HISTORIC PRESERVATION BOARD
City Hall – 1st Floor Board Room, 510 N. Baker Street, Mount Dora, FL
July 26, 2023 at 3:00 PM

RE: **Tab 1 - Certificate of Appropriateness; 813 E 5th Ave (Location); Remove and Replace Four (4) Doors (Request); Hurley Family Partnership (Owner); Sunshine Properties Source, LLC (Applicant).**

RE: Tab 2 - Certificate of Appropriateness; 132 W 9th Avenue (Location); Remove and Replace Front Door (Request); Deborah M. Crawford (Owner); Paul Thomas, Ro-Mac Building Supply (Applicant).

Existing Doors:

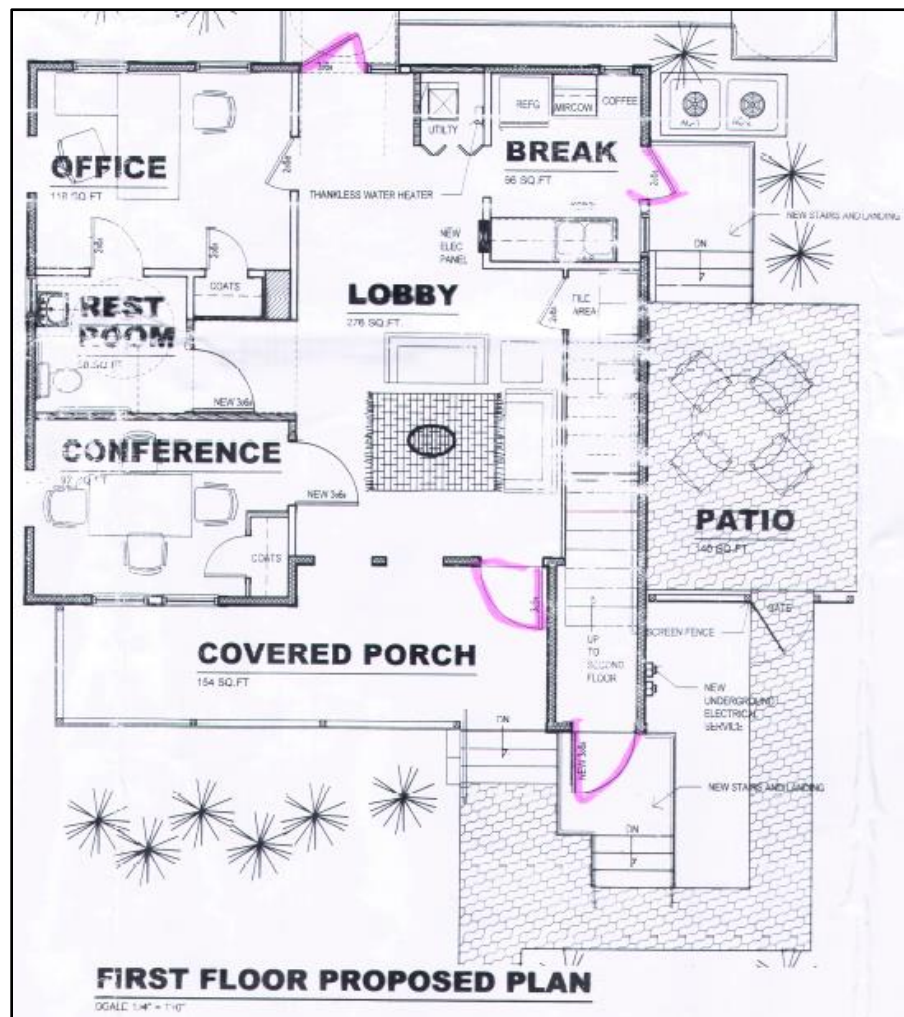
The applicant is seeking to remove four (4) doors (three wood and one fiberglass) and replace them with steel doors; and provide a wrought iron handrail for the existing front stairs. The Applicant stated on the application that the doors are in poor condition and there is currently no handrail on the stairs.

The three wooden doors have grills creating 15 glass panes and the fiberglass door has no windows.

The Applicant is seeking to replace all four doors with steel doors replicating the grids on the existing wood windows.

Staff recommends approval of the application.

Front of Building

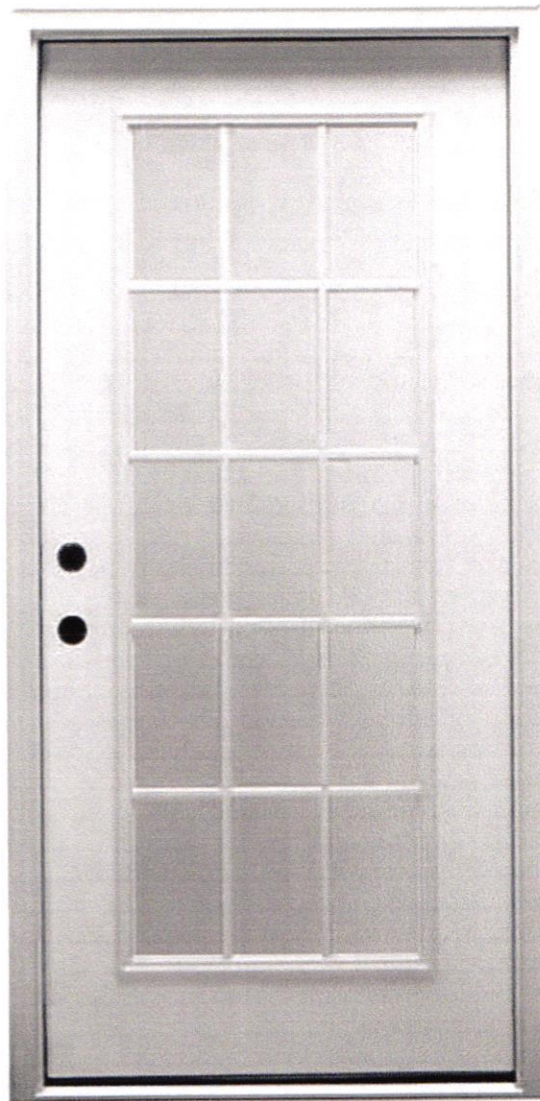
The railing will need to be compliant with Florida Building Code (e.g. min. 12” extension of railing from last step).

Existing doors - replace w/ steel 15 lite door (new)
Existing steps - replace w/ wrought iron railing (new)

DOOR TO BE REPLACED

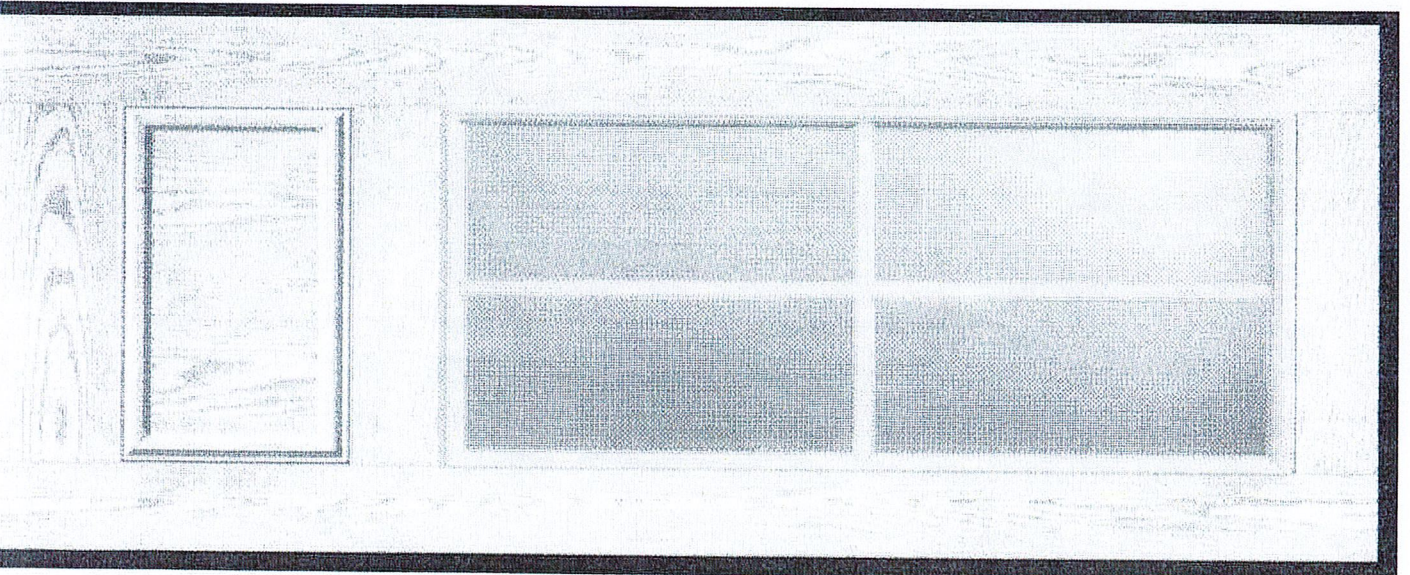
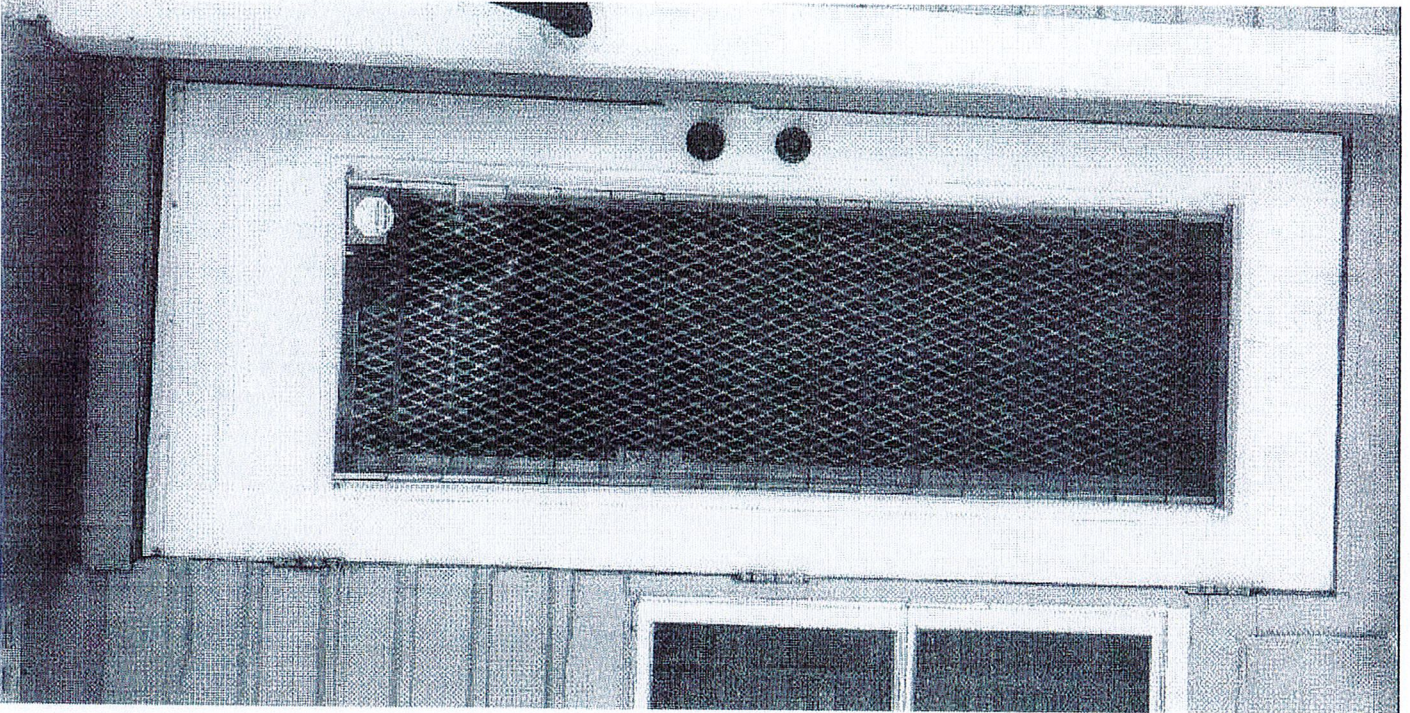
The applicant is seeking to remove an exterior, wood and replace it with a fiberglass door with an oak grain finish. The Applicant stated on the application that the existing door is old and worn out.
